In re Patent No. 6,032,898

Title: MULTIPLE ROLL TOWEL DISPENSER

**PETITION FOR CERTIFICATE OF CORRECTION
PURSUANT TO 37 C.F.R. §§ 1.322 and 1.323**

FIG. 2

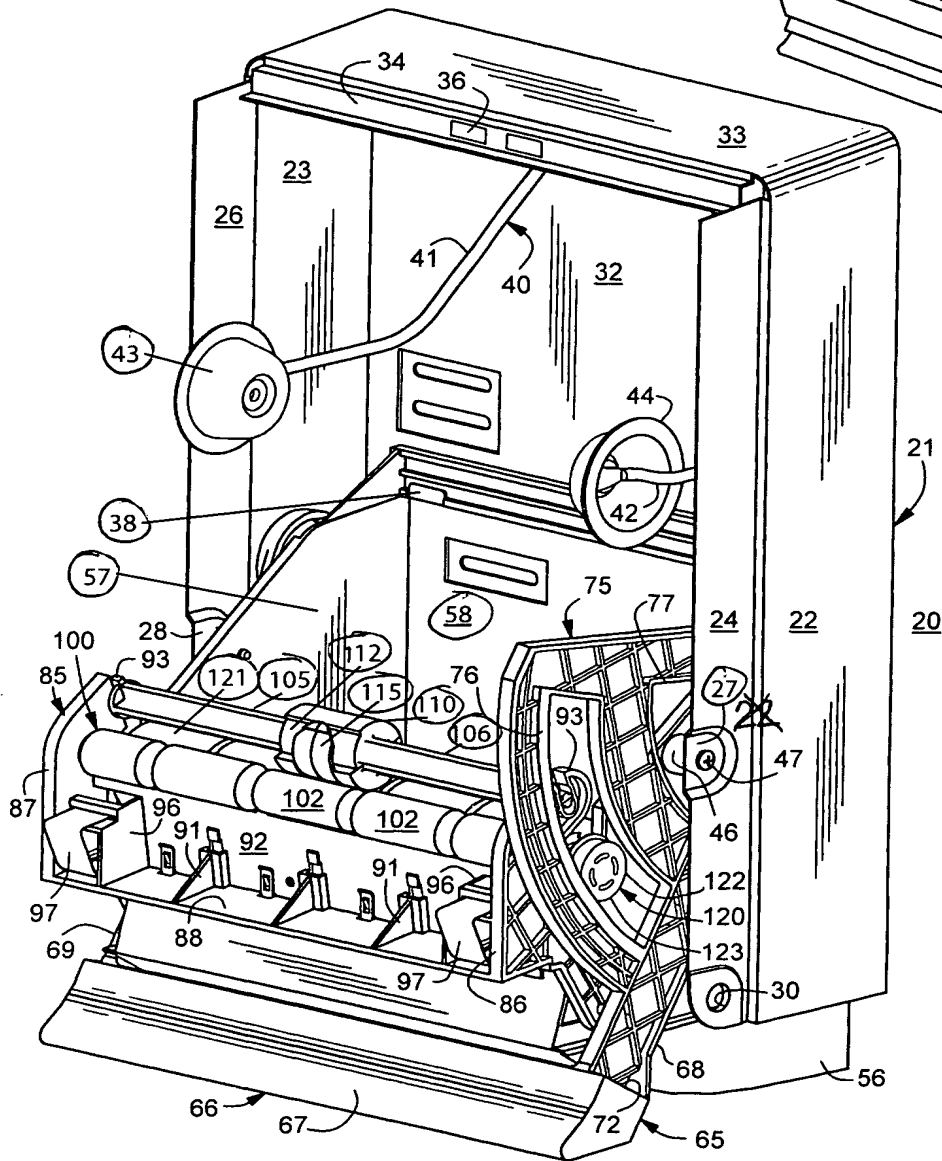
In the drawings, sheet 1, Fig. 2, reference numeral "22" on the sidewall of outwardly extending flange 24 should be deleted and reference numeral --27-- should be applied to the stamped portion;

In the drawings, sheet 1, Fig. 2, reference numeral --43-- should be applied to the left-hand side hub of the paper roll holder assembly 40; reference numeral --58-- should be applied to

the rear wall of the chassis 55; reference numeral --57-- should be applied to the left-hand side spaced parallel side wall of chassis 55; reference numeral --38-- should be applied to the clip extending from the rear wall 32 of the housing 21.

In the drawings, sheet 1, Fig. 2, reference numeral --121-- should be applied to the drive roller segments of the drive roller 120.

In the drawings, sheet 1, Fig. 2, reference numeral --105-- should be applied to the transfer roller assembly; reference numeral --106-- should be applied to the shaft 106 of the transfer roller assembly 105; reference numeral --110-- should be applied to the transfer mechanism; reference numeral --112-- should be applied to the indented or removed portion of the cylindrical portion 111 of the shaft 106; reference numeral --115-- should be applied to the snap clip which receives the indented or removed portion 112 of the cylindrical portion 111 of the shaft 106.

FIG. 6

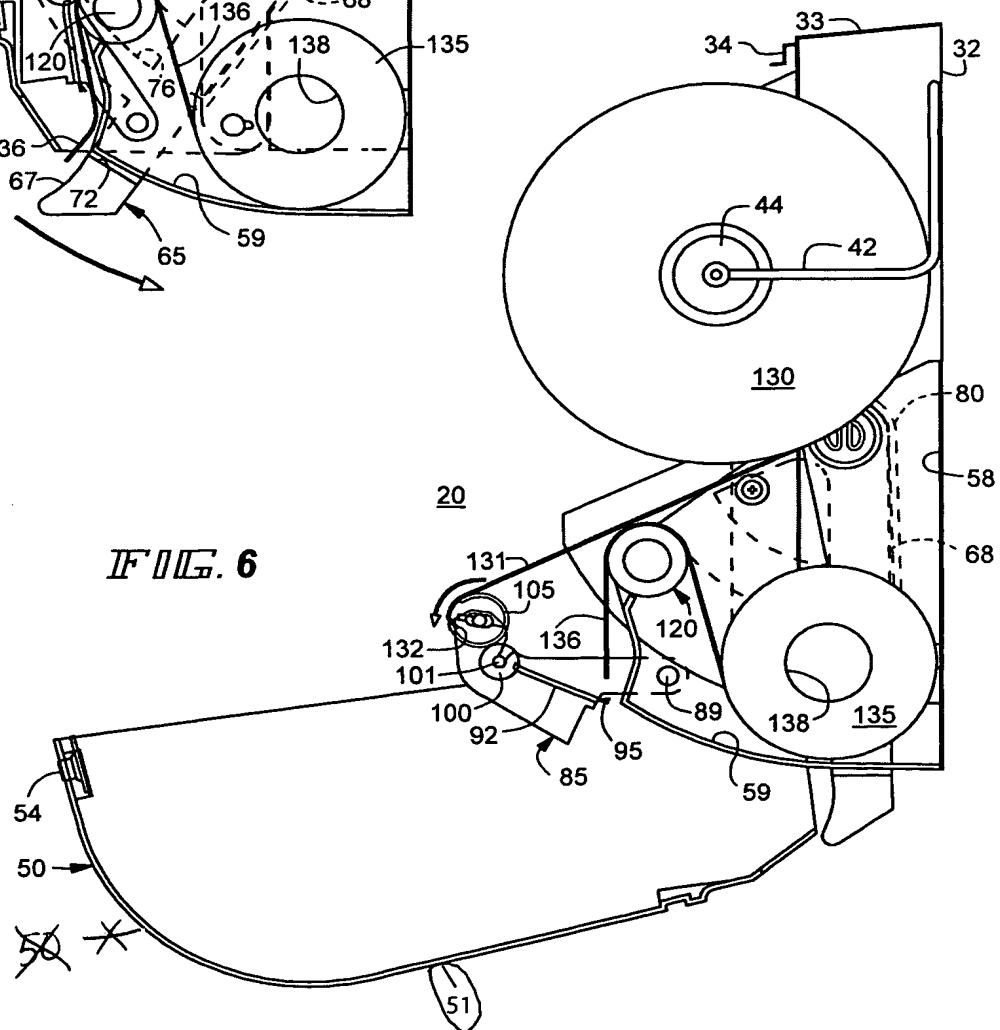
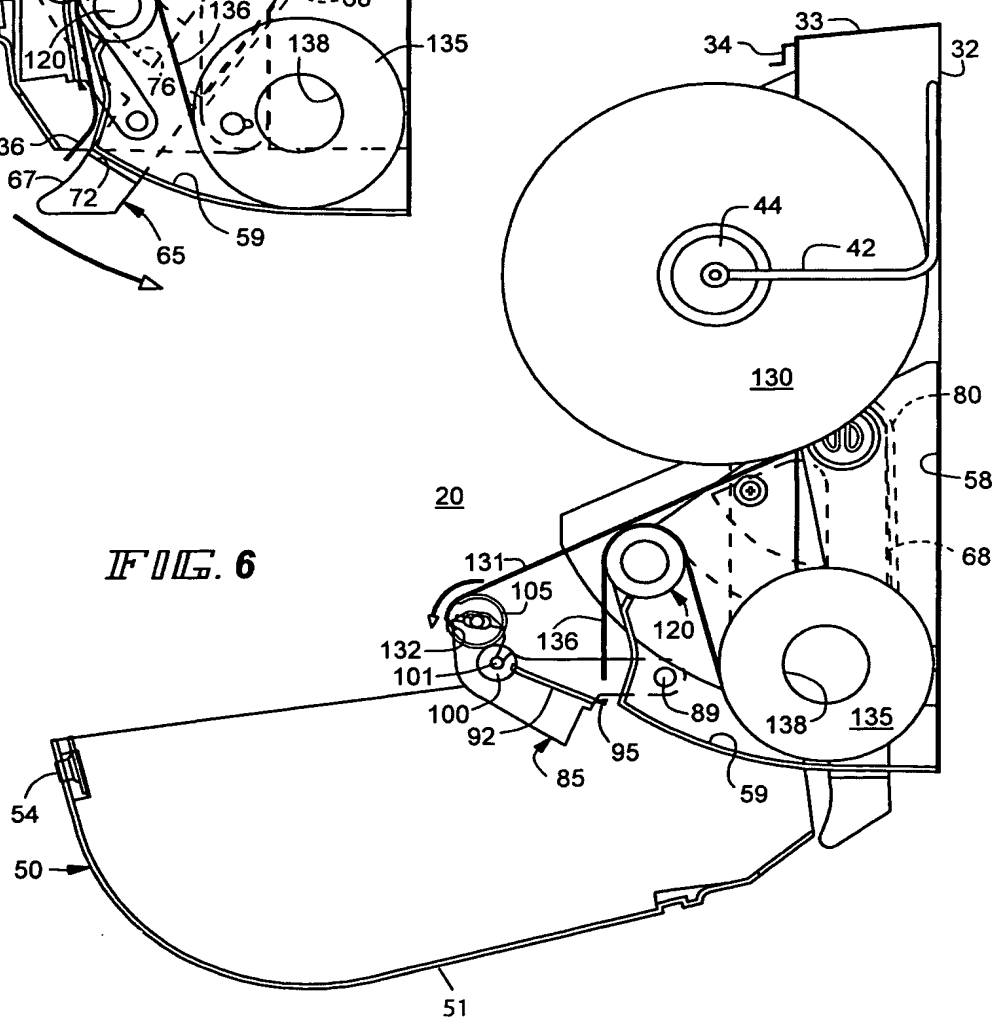
In the drawings, sheet 3, Fig. 6, the reference numeral "50" (not the reference numeral "50" pointing to the cover) should be deleted and reference numeral --51-- should be applied to the front panel of the cover 50.

FIG. 10

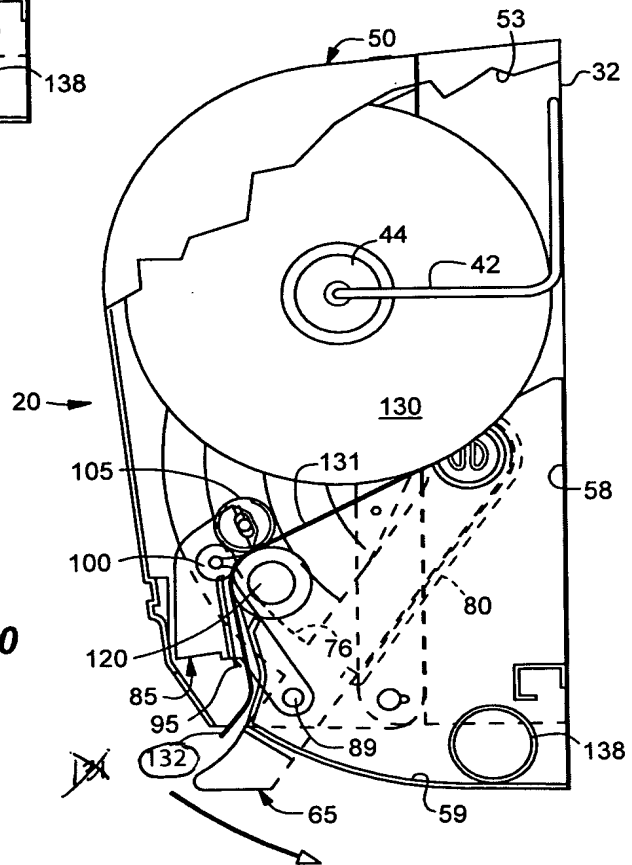
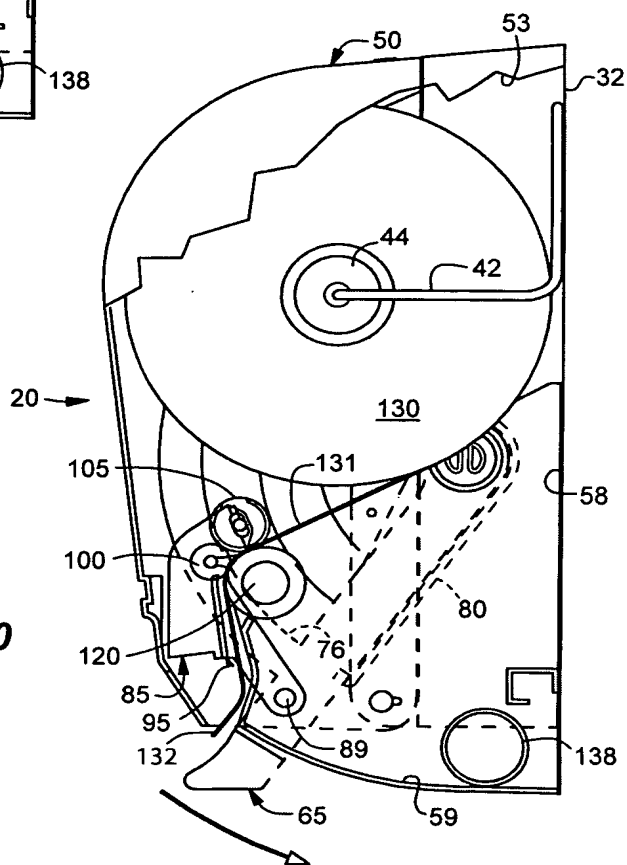
In the drawings, sheet 4, Fig. 10, the reference numeral "131" pointing to the free end of the flight of paper 131 should be deleted and the reference numeral --132-- should be applied to the free end of the flight of paper 131.
